Transport Assessment Addendum

Land north of Balcombe Road,
Haywards Heath

April 2026

Proposed Access Arrangement

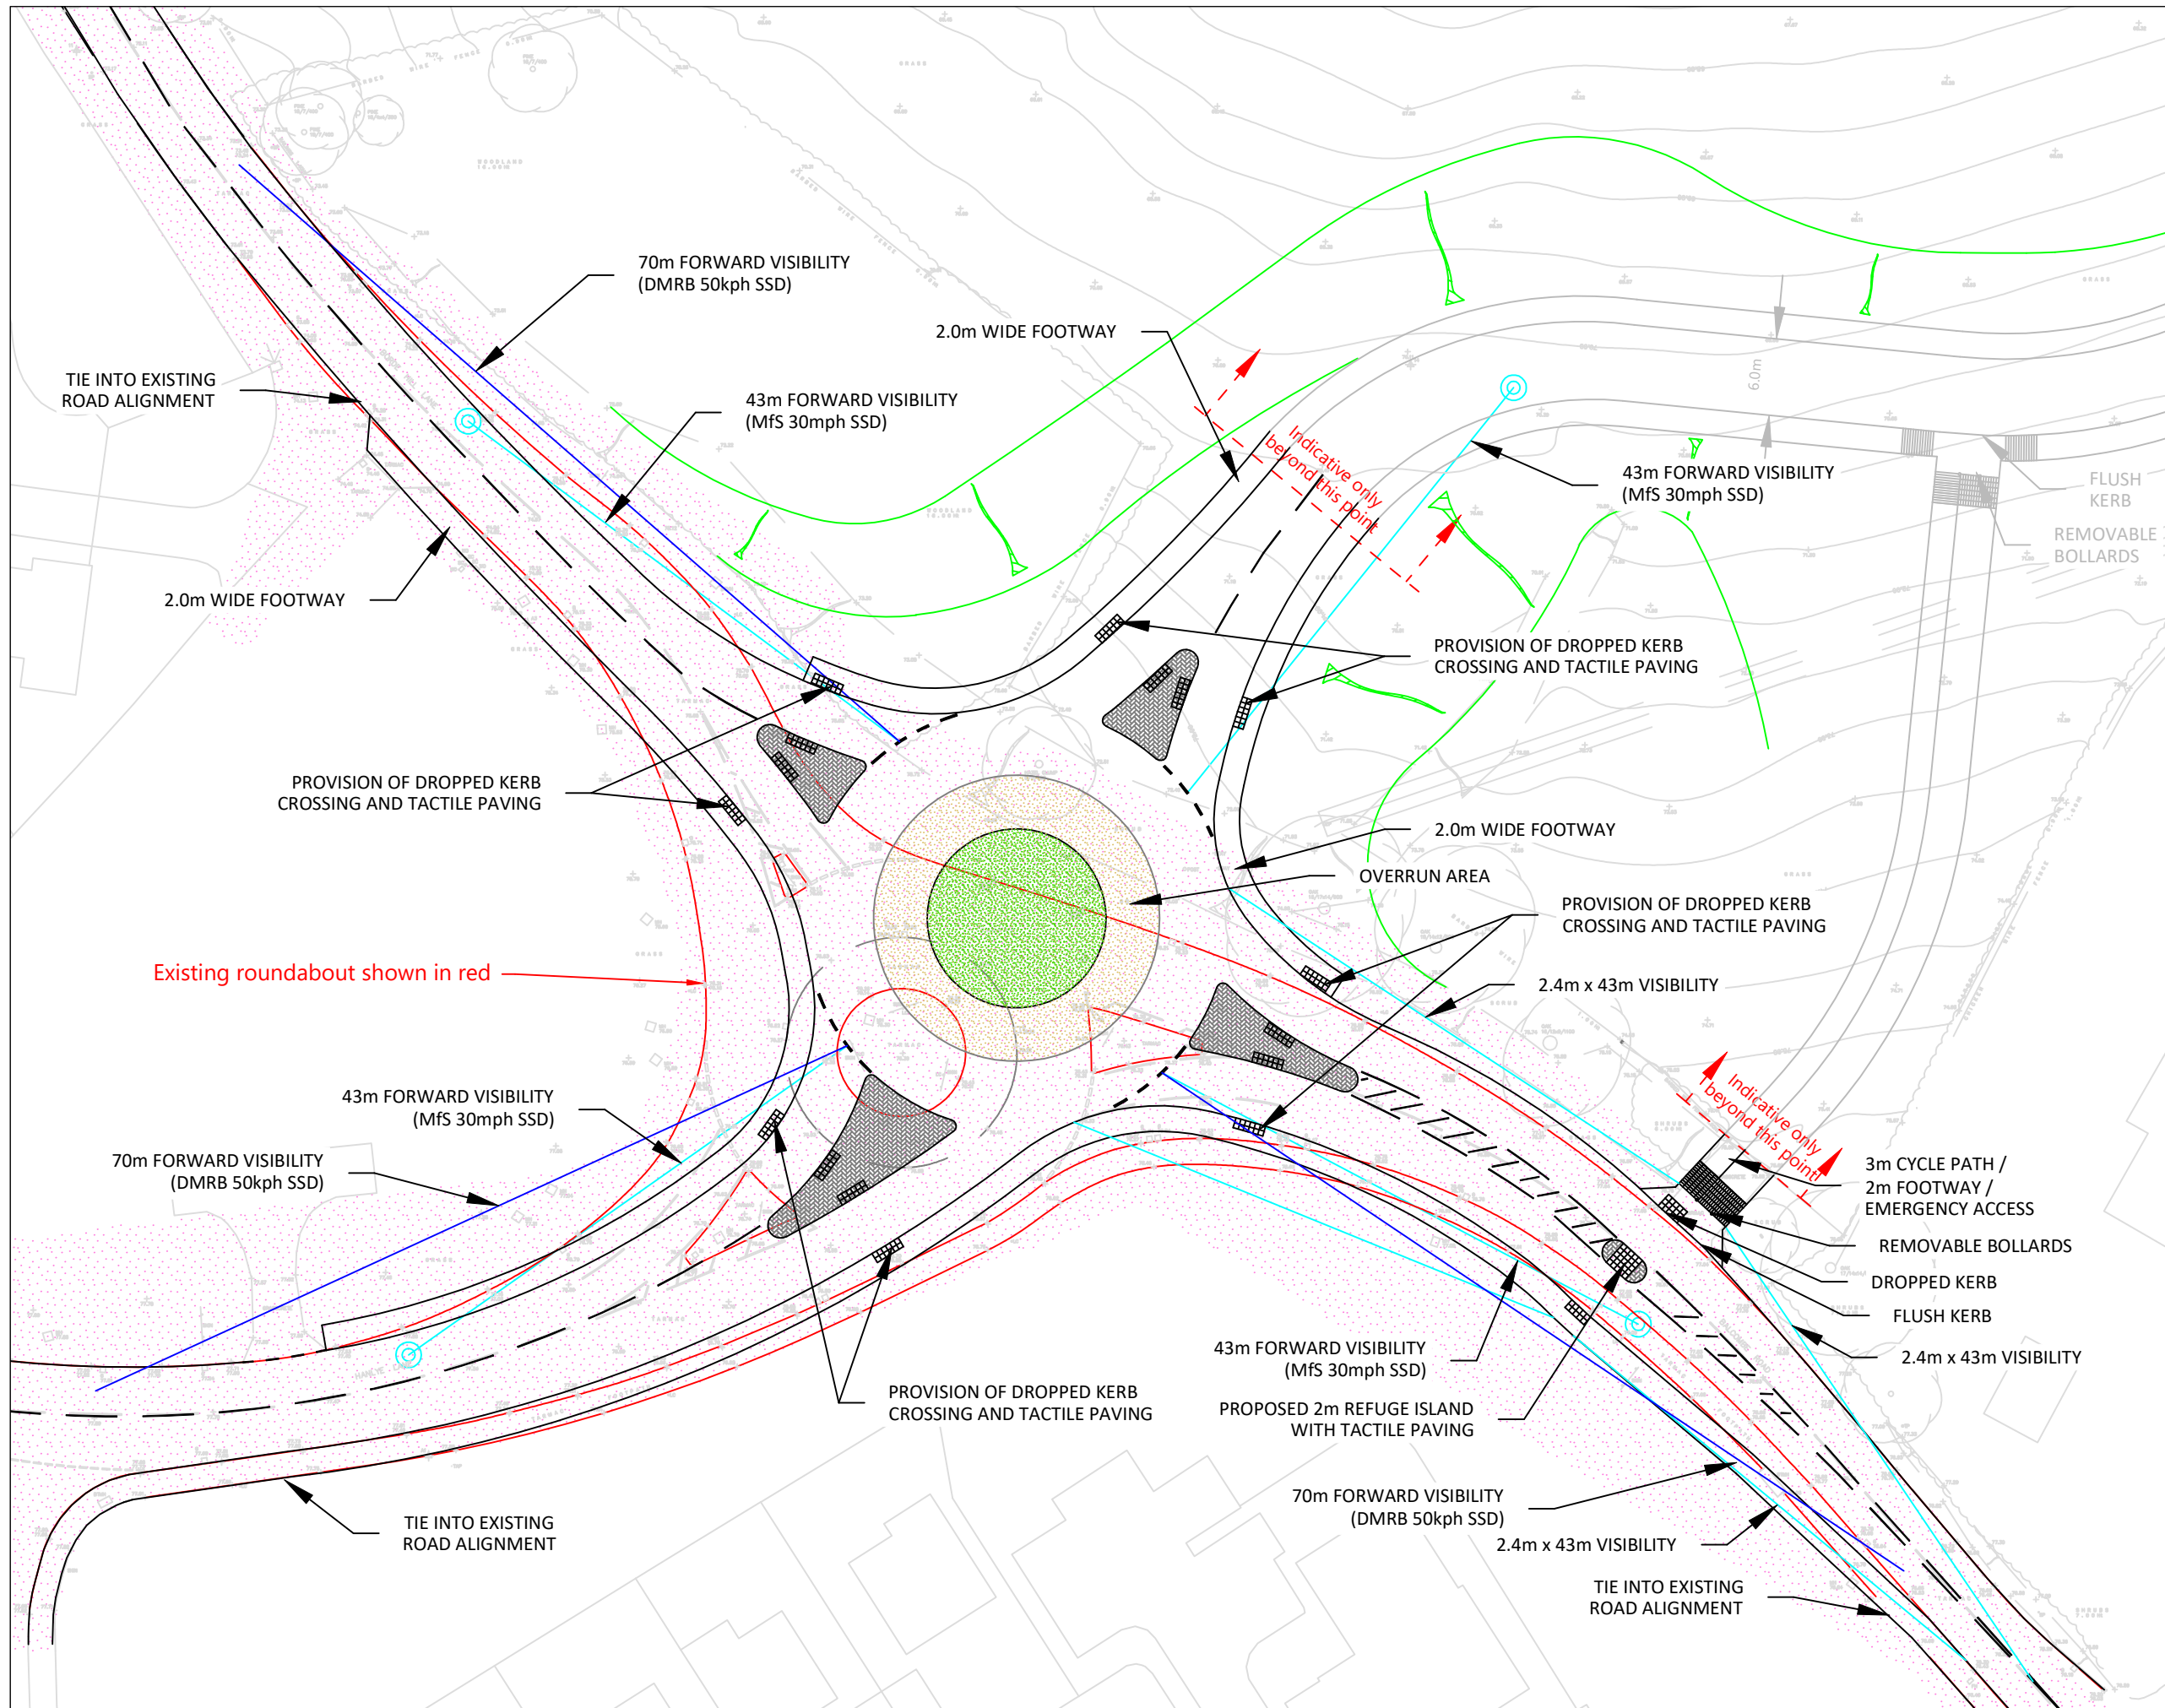
- 3.4.1 Page 2 of the WSCC response lists eight points requiring additional information relating to the roundabout. Responding to the points in turn:
- 1) The revised geometry and visibility splays (including pedestrian and cycle crossing points) are shown on Drawing 352 along with references to the relevant clauses in CD116 and associated documents.
 - 2) The compact roundabout now includes an over-runnable area intended to be used by large vehicles such as buses and articulated lorries. Swept path vehicle tracking for vans, refuse vehicles, buses and 16.5m articulated vehicles are included on the revisions to the drawings.
 - 3) The proposed footway has been extended on the north side of the roundabout and a pedestrian crossing provided across the Borde Hill Lane arm of the roundabout. Full pedestrian crossing provision is therefore provided across all four arms of the roundabout.

- 5) The shared-use pedestrian and cycle path is proposed to have tactile paving, low/flush kerbs, road markings and signage at each end to highlight the change in conditions. Drawing 305 shows the proposed tactile paving layout showing the intended segregation of pedestrians at the refuge island, and the adjacent cycle path. Cyclists turning right into the site at this point will benefit from the protection provided by the refuge island if having to wait in the centre of the carriageway. The visibility at this access and pedestrian crossing are shown on Drawing 305. Removeable bollards are proposed that would allow access by adapted cycles when in place, and by emergency vehicles when removed. The layout of this path at its northern end is indicative and will be developed further at detailed design stage.

3.4.1 **Location:** Proposed pedestrian crossing points on Access Road and Balcombe Road at the roundabout.

3.4.2 **Location:** Proposed pedestrian refuge on Balcombe Road.

3.4.3 **Location:** At the cycle link.

- 3.2.3 Drawing SDP-XX-XX-DR-D-305/P7 shows the proposed compact roundabout layout. This includes the addition of a footway on the northern side of the junction and tactile crossing point on the Borde Hill Lane arm of the roundabout.

- 3.3.1 Further details have been provided on Drawing SDP-XX-XX-DR-D-305/P7 for the proposed pedestrian and cycle link, showing the visibility at this access and for pedestrians using the refuge island crossing. Removeable bollards are proposed that would allow access by adapted cycles when in place, and by emergency vehicles when removed.

- 6.8 Item 3.4.3 recommends that cycle facilities should link or allow cyclists to leave and rejoin the carriageway. It is expected that this link will primarily be used by cyclists travelling to and from the south and that the layout in conjunction with the refuge island provides an appropriate arrangement for cyclists as an alternative to using the roundabout junction.

Drawing No.	SDP-XX-XX-DR-D-310	Revision	P5

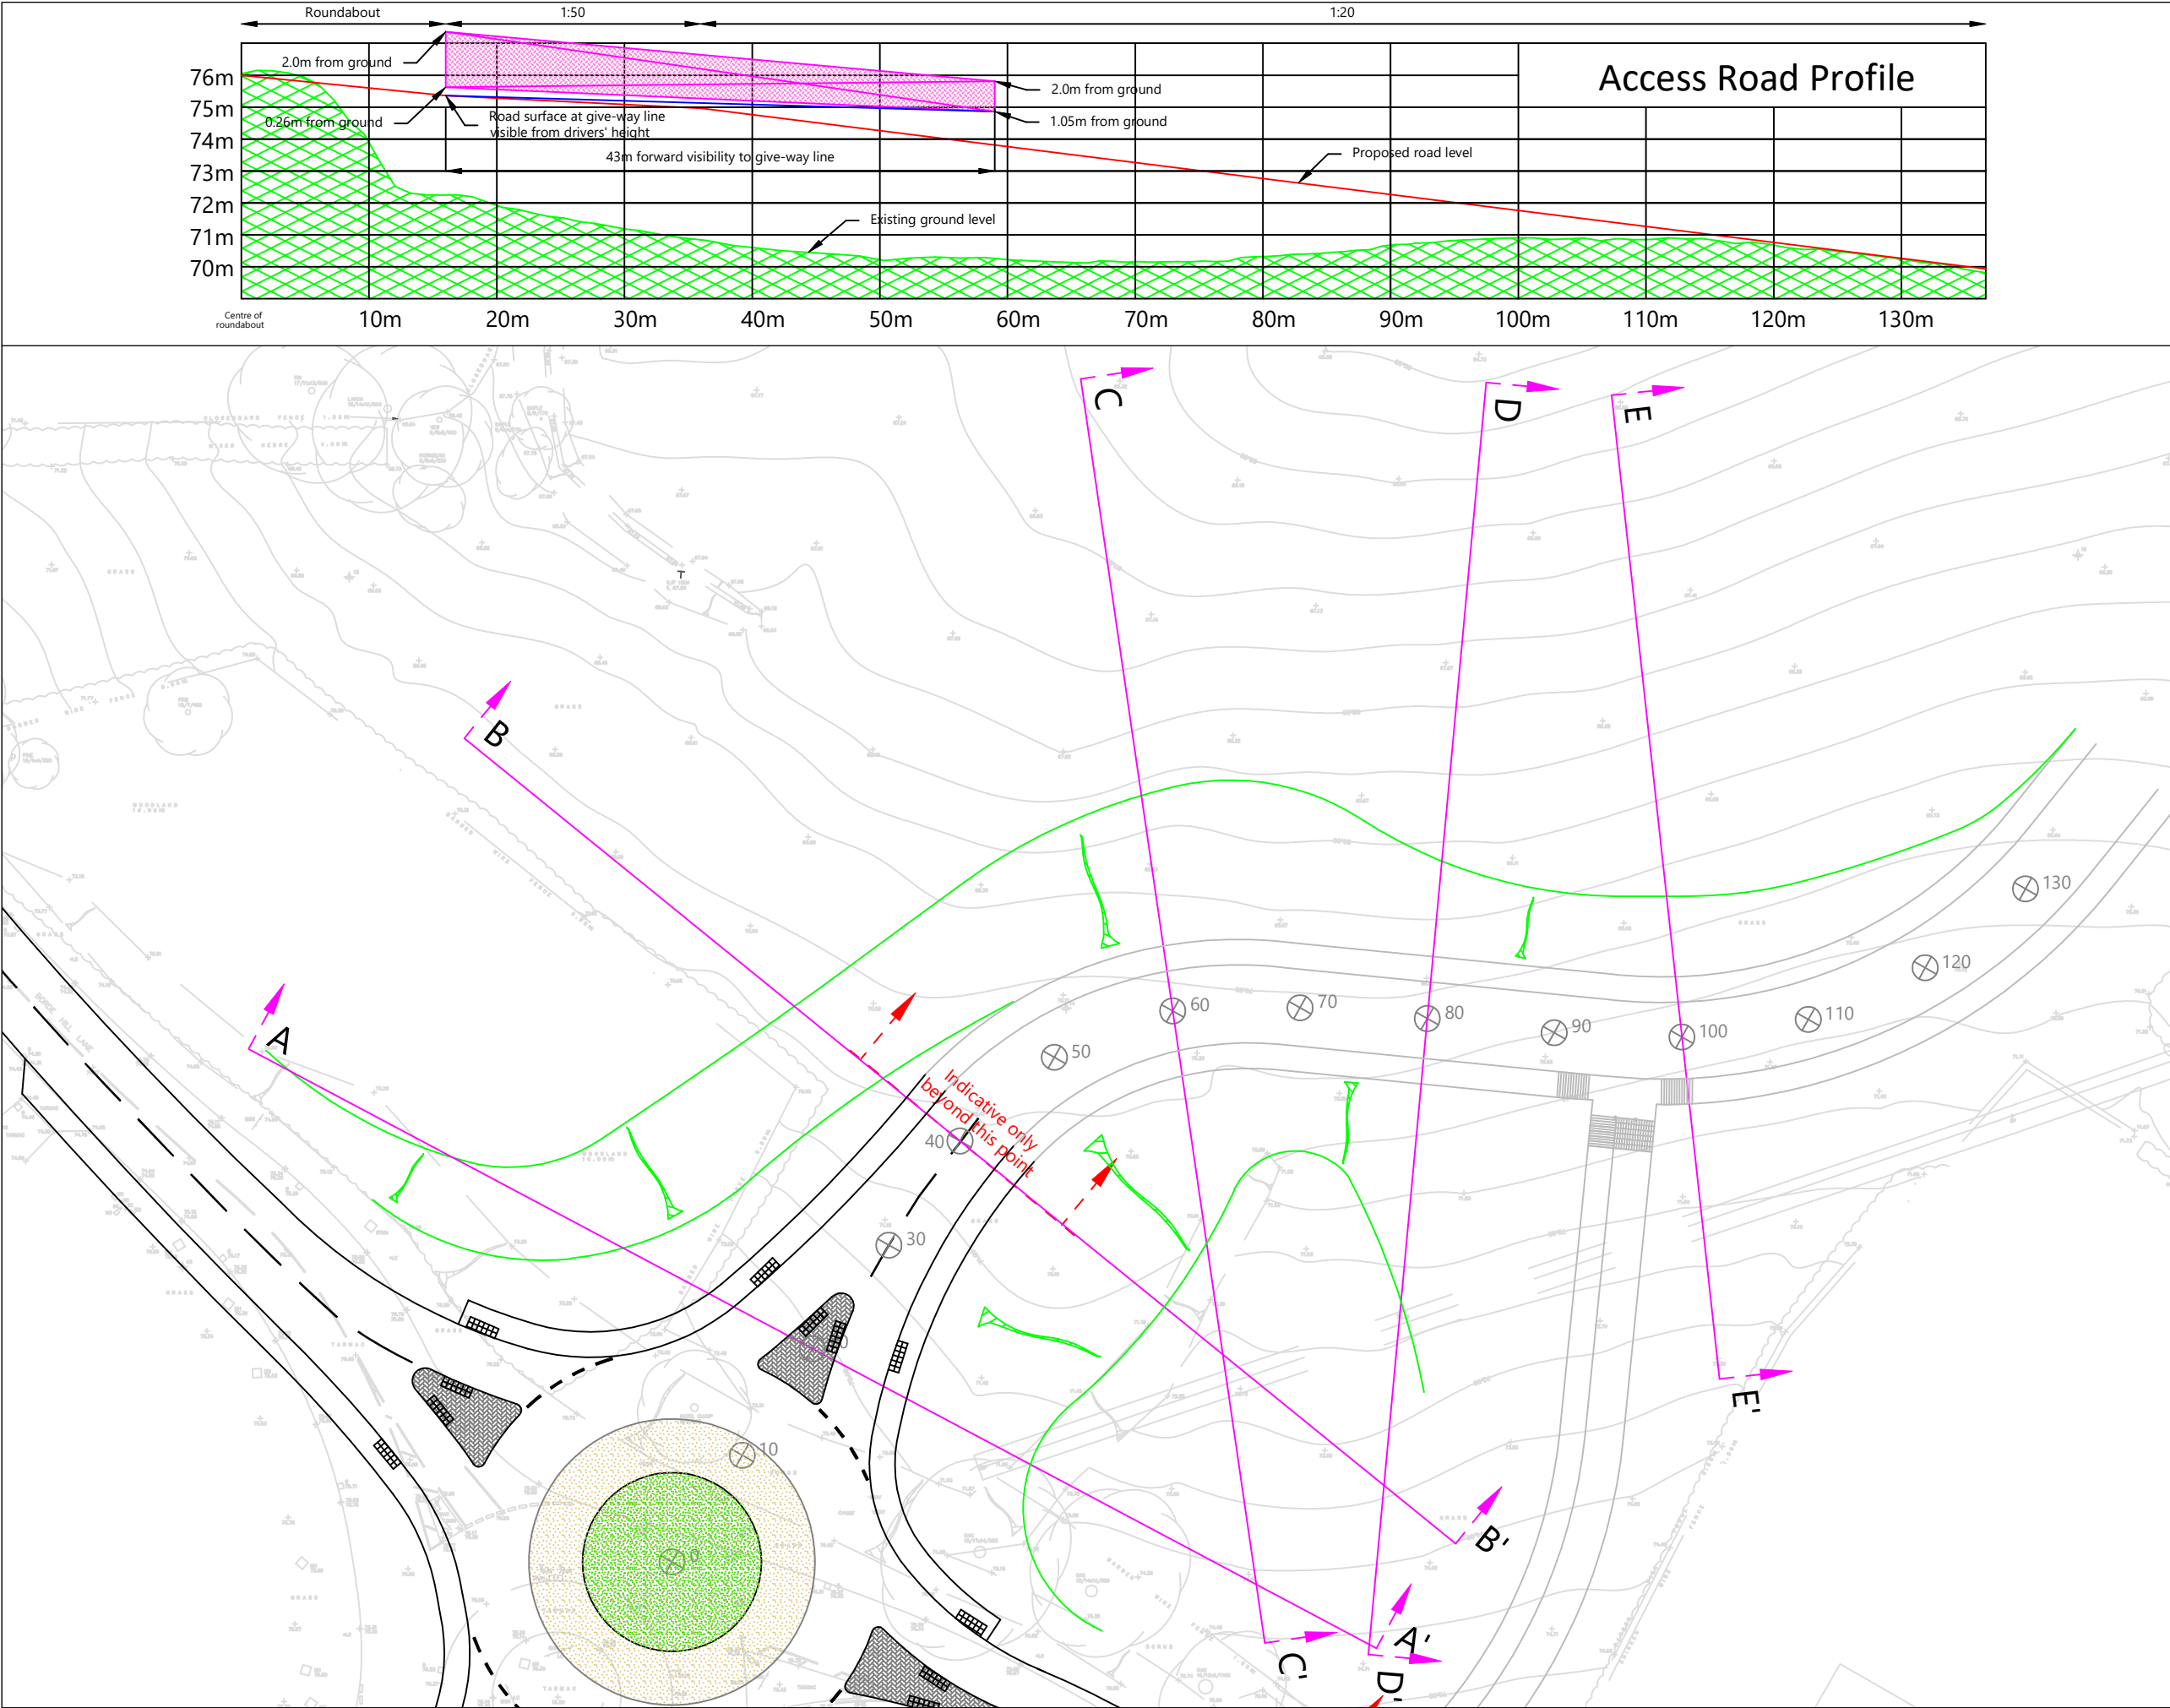
- 6) The forward vertical visibility along the access road is shown in the profile on Drawing 310. This shows that the give-way line at the roundabout can be seen by drivers from 43m back from the junction along the proposed road alignment.

3.2.2 **Location:** The proposed roundabout.

3.2.3 **Location:** Development approach to proposed roundabout.

- 3.2.6 Drawing SDP-XX-XX-DR-D-310/P5 shows the vertical profile of the development access. This shows that the give-way line at the roundabout can be seen from a driver's eyeline when approaching the junction. Drawing SDP-XX-XX-DR-D-311/P3 shows cross-sections at the locations marked in Drawing 310.
- 3.2.7 Drawings SDP-XX-XX-DR-D-353/P4, SDP-XX-XX-DR-D-354/P5, SDP-XX-XX-DR-D-355/P5 and SDP-XX-XX-DR-D-356/P3 show swept path vehicle tracking for turning movements at the junctions for van, refuse vehicles, buses and articulated lorries. The drawings shows that all movements can be achieved within the available space without over-running footways or traffic islands.
- 3.2.8 A design audit of the proposed access arrangements can be found in Appendix C. This provides further information on the design of the access and cross-references paragraphs from CD 123 and other design documents.

- 6.5 Item 3.2.2 refers to the access road's gradient on the approach to the roundabout. Drawing 310 confirms the gradient is 2% for the initial 20m from the give way line.

- 6.6 Item 3.2.3 refers to the forward visibility along the access road towards the junction. Forward visibility to an object height of 0.26m, and indeed ground level, is achievable as shown on Drawing 310.
